**CITY OF PORTLAND, MAINE
DEVELOPMENT REVIEW APPLICATION
PLANNING DEPARTMENT PROCESSING FORM**

Maggie Lane lot 12

RE: Response to your comments on lot # 12 Maggie Lane

RE: DAN - THE LOT #12 PLAN SUBMITTED TO YOU
ON 11-7-00 DOES NOT ADDRESS ANY OF THE POINTS
OUTLINED IN MY LETTER THAT WAS FAXED TO
YOU ON 11-1-00. (ATTACHED) SUBMIT A PLAN
THAT ADDRESSES THESE ISSUES. ALSO SUBMIT A
PLAN THAT IS TO SCALE. RIC

Drawing Name:
Grading & Drainage- Lot 12
Project:
MAGGIE LANE, PORTLAND

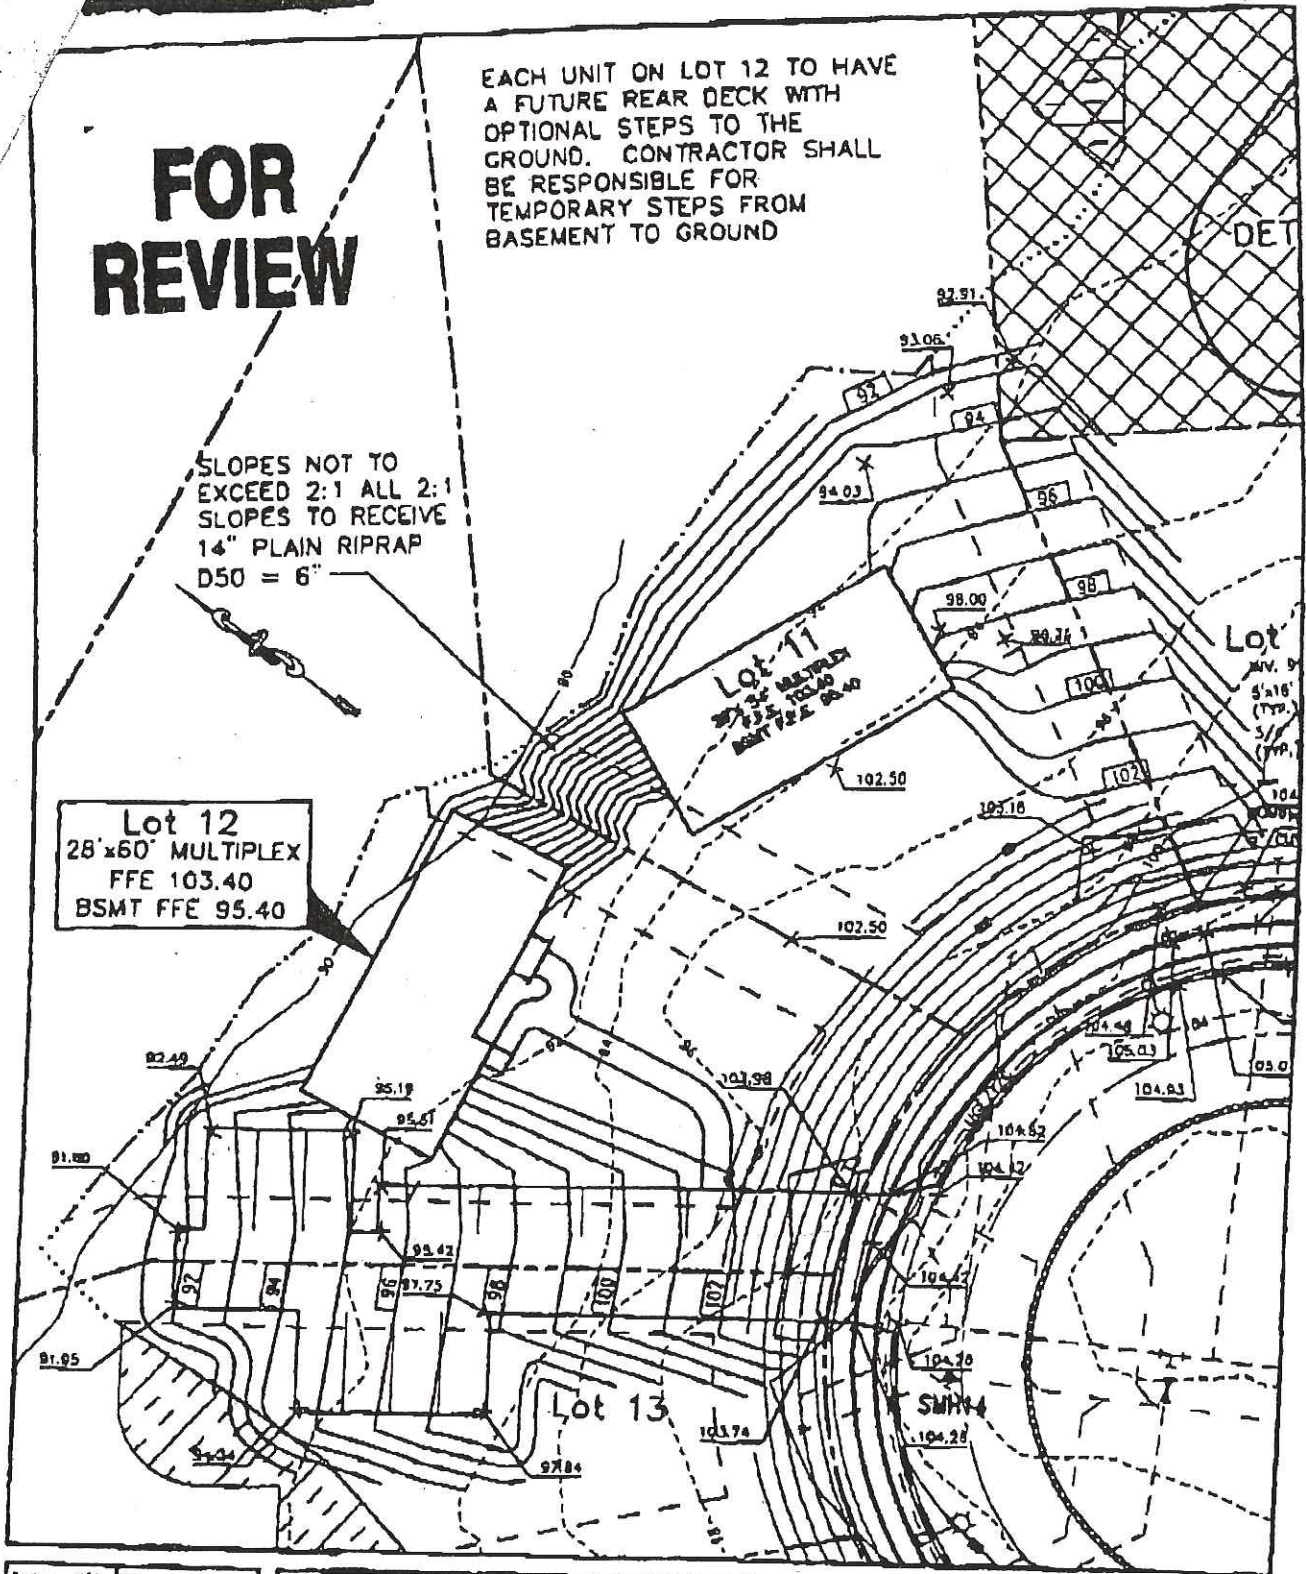
2. SUBMIT SPECIFIC SLOPE STABILIZATION MEASURES ON THE PLAN. ONE OPTION IS TO MAKE IT LESS STEEP. WE WILL NOT ACCEPT MORE THAN A 3 TO 1 SLOPE. *OR hand draw w/ explanation*

The area in question is ~~28 x 32 x 22 x 24~~
~~is proposed as a~~ joint side yard
between buildings on lots 11 and 12.
This side yard is proposed as a
riprap ~~2 to one~~ 2 to 1 slope
dropping 12' in elevation over a
24' run. ~~White a rip~~

~~The condition of approval is a~~
maximum slope of 3 to 1 with
a grass finish. The recommendation
of the DRC consulting engineer Steve
Barshy is to install two small
retaining walls, 2-3' tall, or a
series of steps, which would allow
a terraced lawn in the side yard
of 3 to 1 or 4 to 1 slope steepers.
Please submit a revised plan
with the maximum slope as specified.
Until this issue is resolved, we cannot
grant approval of the plan as submitted.

1. The decks and stairs have been added to the site plan.
2. Gorrill-Palmer & Steve Bushy from Deluca - Hoffman, both agree that RipRap is an acceptable slope stabilization measure. There is no way to get a 3 to 1 slope with a 12' drop over 24'. Both the Buyers for lots 11 & 12 do not want retaining walls between buildings for liability and maintenance reasons. If we bring the slopes out past the front of the Buildings the sides would have to become a daylight basement, this would effect our building envelope, grading and final appearance that the purchasers are looking for. We have been patient with this process but we feel it is putting extra burden and is unreasonable to force the purchasers into something they do not want.
